ABINGTON TOWNSHIP

BOARD OF COMMISSIONERS
COMMITTEE OF THE WHOLE

b. Consider approving the major subdivision application for 1231 Susquehanna Road, Rydal. *(Mr. Hassan)*

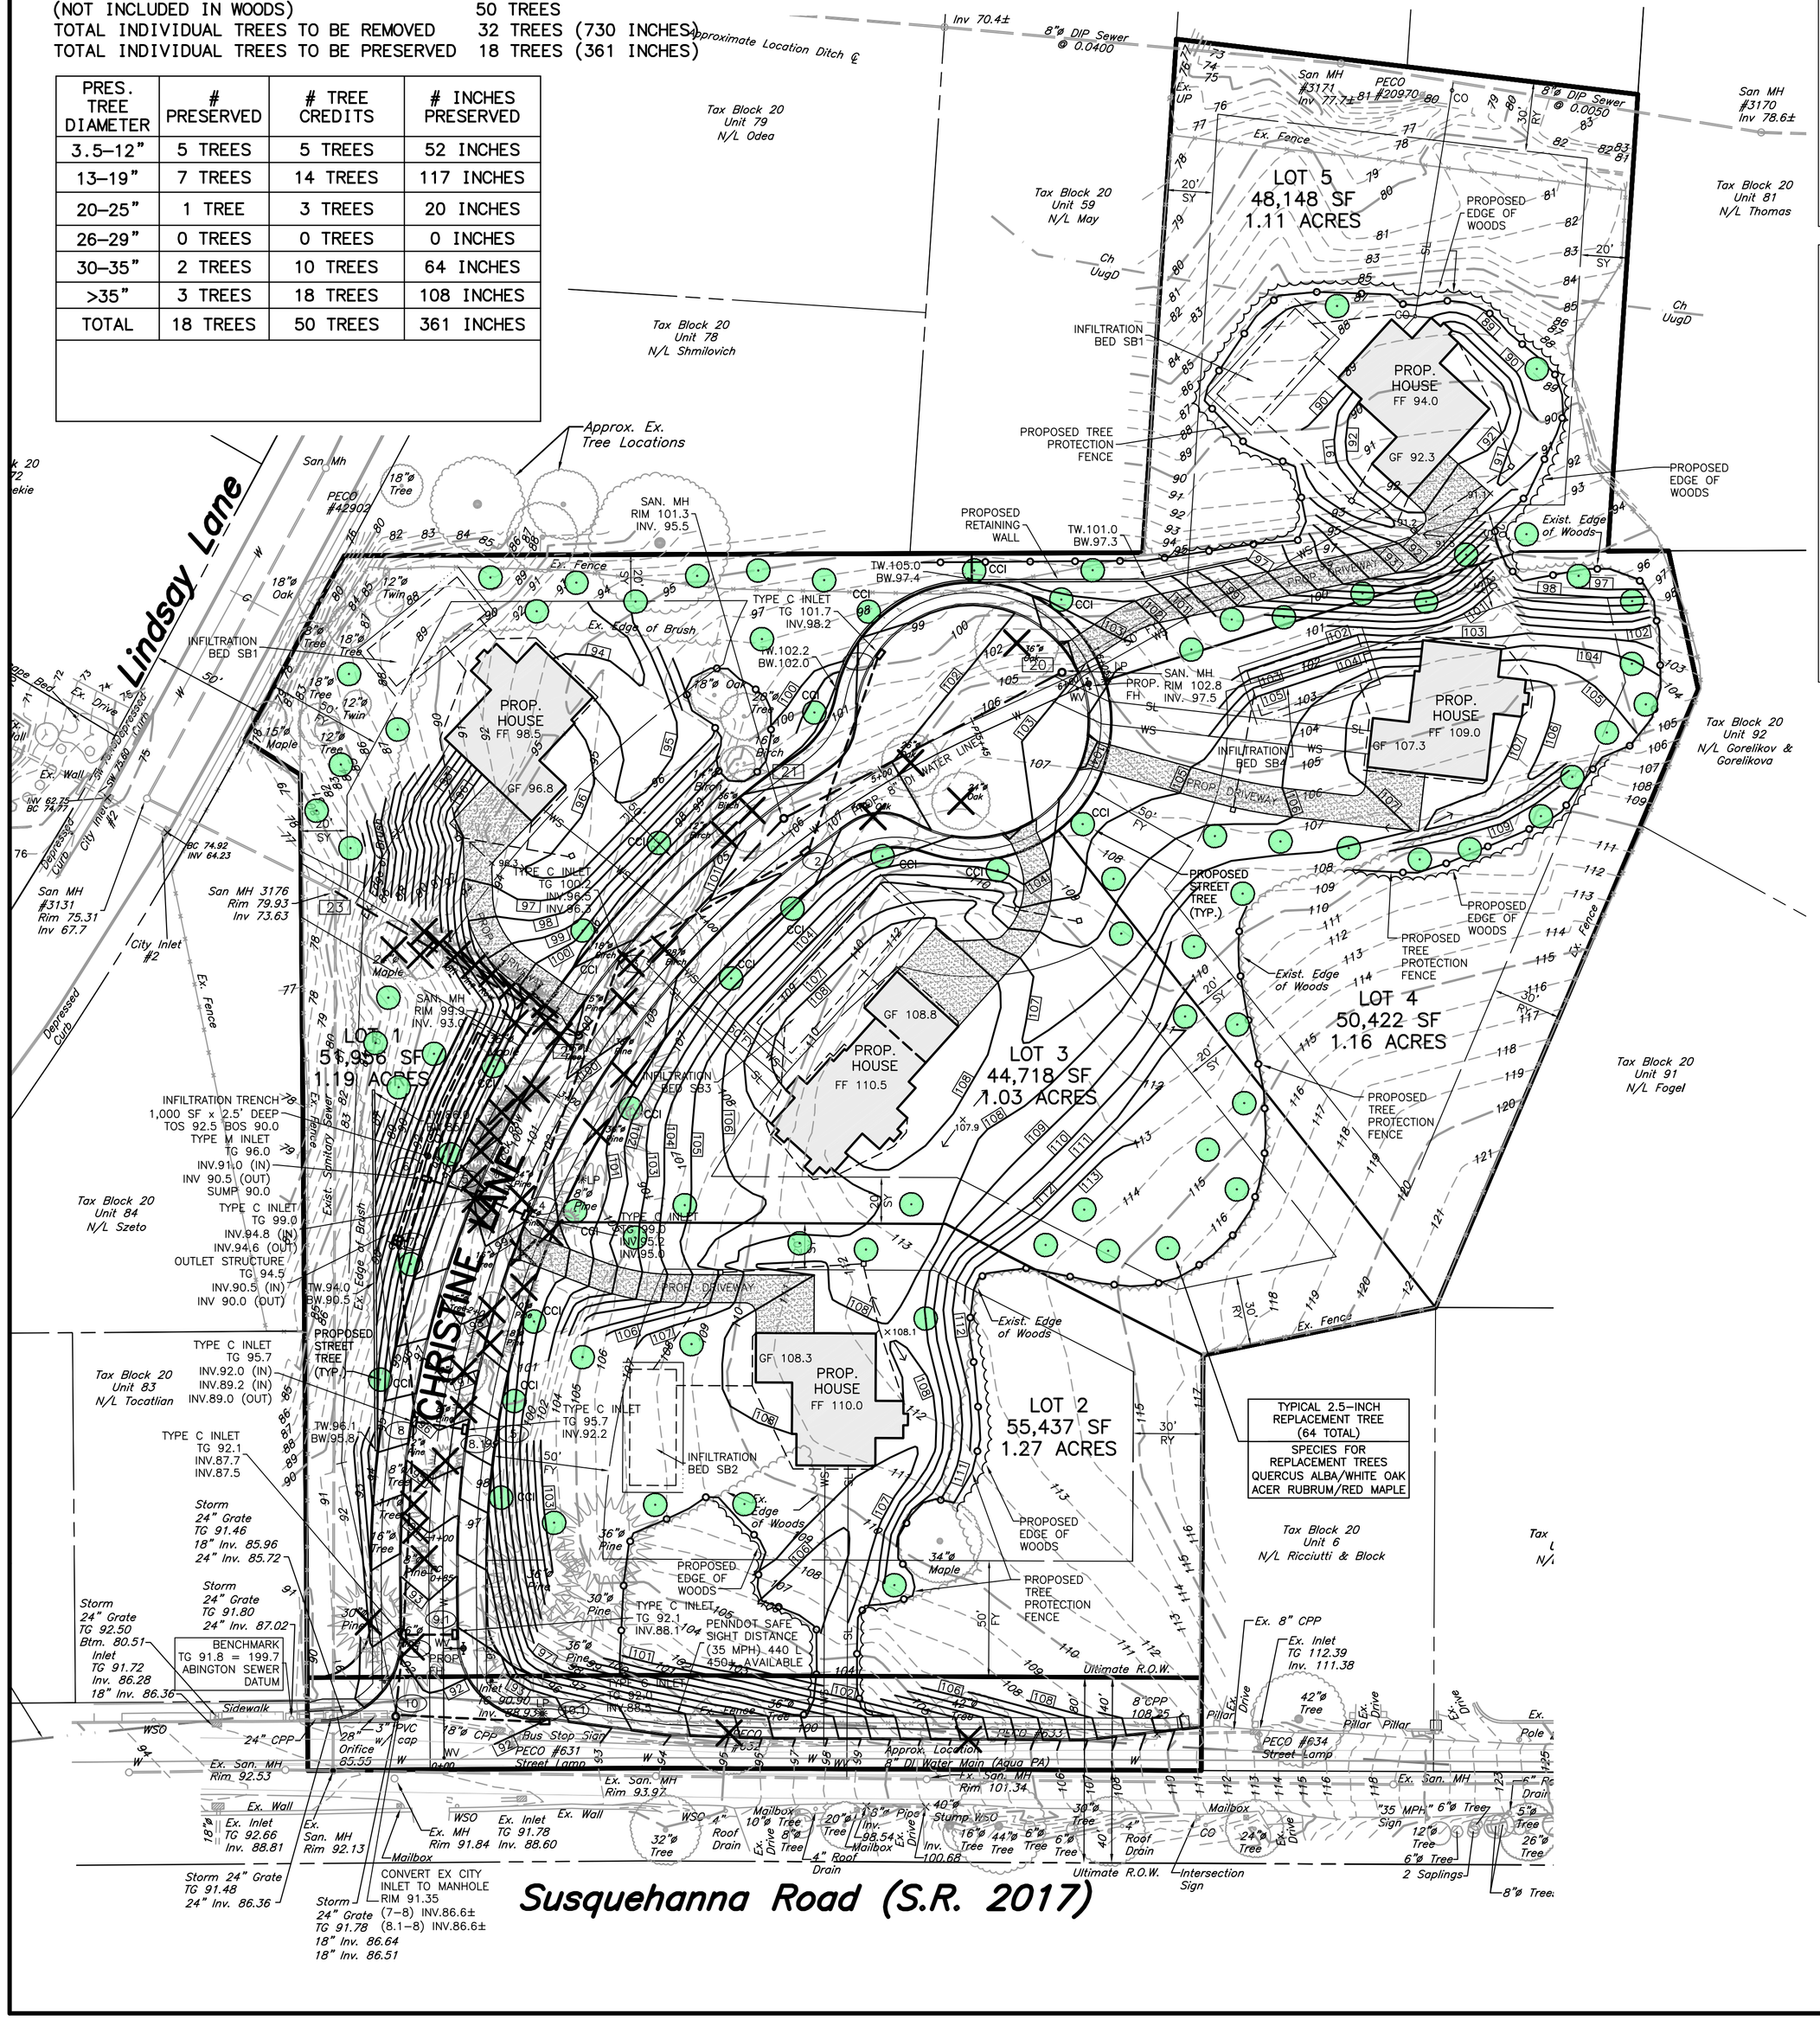
3. In accordance with Section 2401.A.(2)(d)(1), tree replacement must be performed as outlined in this Section. Tree replacement calculations and a tree replacement table must be provided on the Landscape Plan (Sheet 5 of 7) which shows the size, number and type of trees proposed to be removed and the number, size and type of replacement trees to be

In addition, the replacement trees must be shown in the plan view of the Landscape Plan (Sheet 5 of 7).

37. In accordance with Section 146-11.H.(1), "the landscaping plan shall be prepared by a registered landscape architect." *The Landscape Plan (Sheet 5 of 7) must be prepared, signed and sealed by a registered landscape architect.*

52. Section 149-39.B.(4)(a) Tree Table on the Landscape Plan (Sheet 5 of 7) notes that "Preserved Trees exceed Removed Trees in both number and inches." However, the Table

53. In accordance with Section 146-39.C, all proposed landscaping shall be guaranteed by the subdivider or developer for a period of one (1) year after the Township issues an occupancy permit. It shall be the responsibility of the subdivider or developer to protect and maintain new and existing plant materials during this period. An inspection shall be made by the Township at the end of the one (1) year period and any plant materials unacceptable at that time shall be replaced. *Note 12 on the Landscape Plan (Sheet 5 of 7) must be revised to state these requirements.*

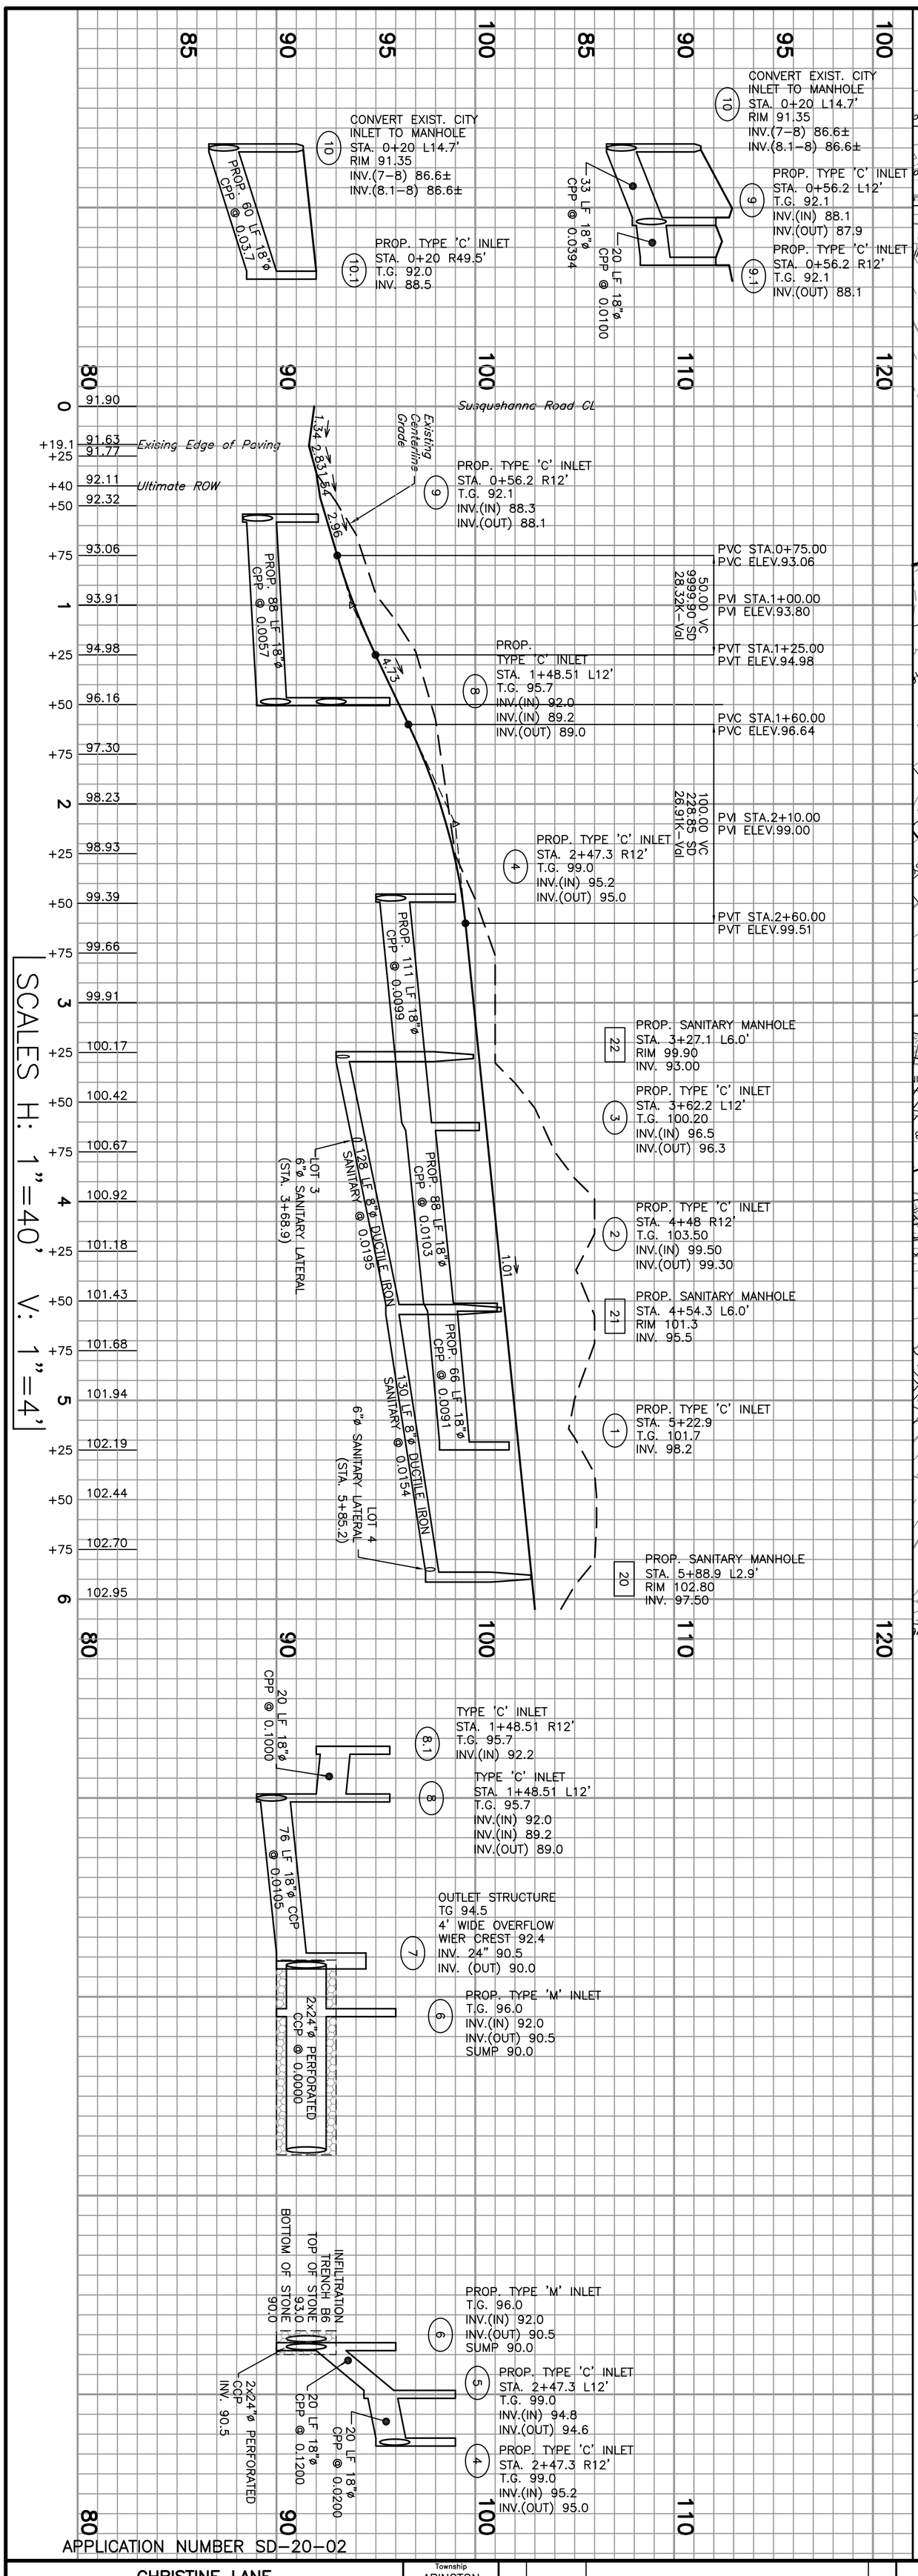
1. In accordance with Section 302, Figure 3.1, the minimum Front Yard setback is 50 feet. *The Front Yard Setback of Lot 1 from Susquehanna Road must be labeled and dimensioned on the Subdivision Plan (Sheet 1 of 7).*

7. In accordance with Section 146-11.A.(5), the total site acreage shall be shown on the Plans. *Note No. 5 on the Subdivision Plan (Sheet 1 of 7) must be revised to also give the site area in acres.*

67. Note 11 on the Subdivision Plan (Sheet 1 of 7) refers to Waivers granted and requested. The Waivers which were previously granted were for a different project layout in the past and are no longer valid for the current project. The note must be revised to only list requested Waivers.

68. Note 12 on the Subdivision Plan (Sheet 1 of 7) refers to Special Exception granted to allow disturbance of steep slopes. The Special Exception which was previously granted was for a different project layout in the past and is no longer valid for the current project. The note must be removed from the Plan.

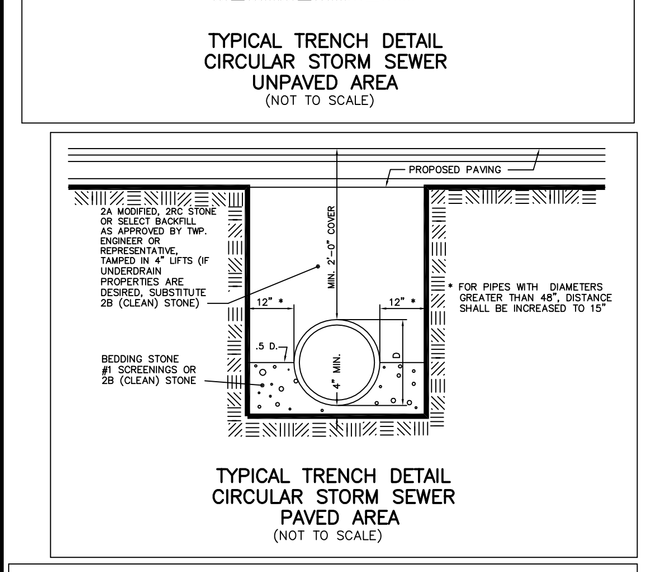
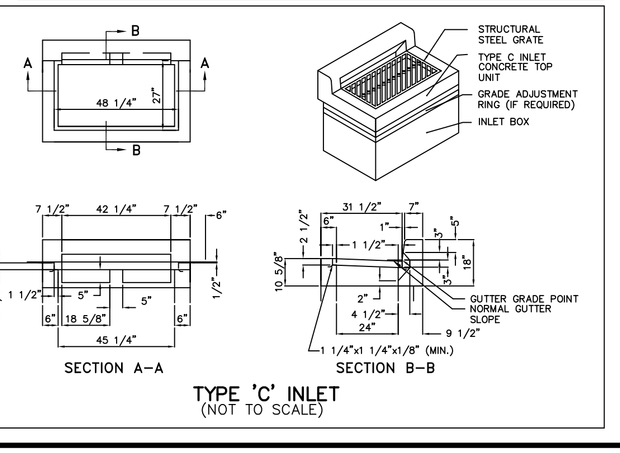
j. *The Detail Plan (Sheet 7 of 7) shows a detail for 18 inch silt fence. Since a sediment basin is not proposed for the project, we recommend that super silt fence is used instead of the 18 inch silt fence to prevent sediment from leaving the site. The Detail Sheet should be revised to include a detail for super silt fence.*

CONCRETE WASHOUT DETAIL
NTS

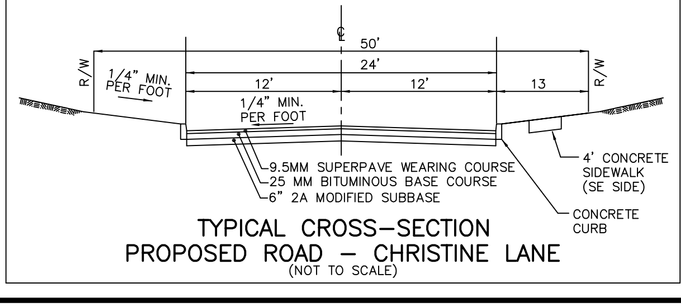
e. *The concrete washout detail must be added to the Detail Sheet (Sheet 7 of 7).*
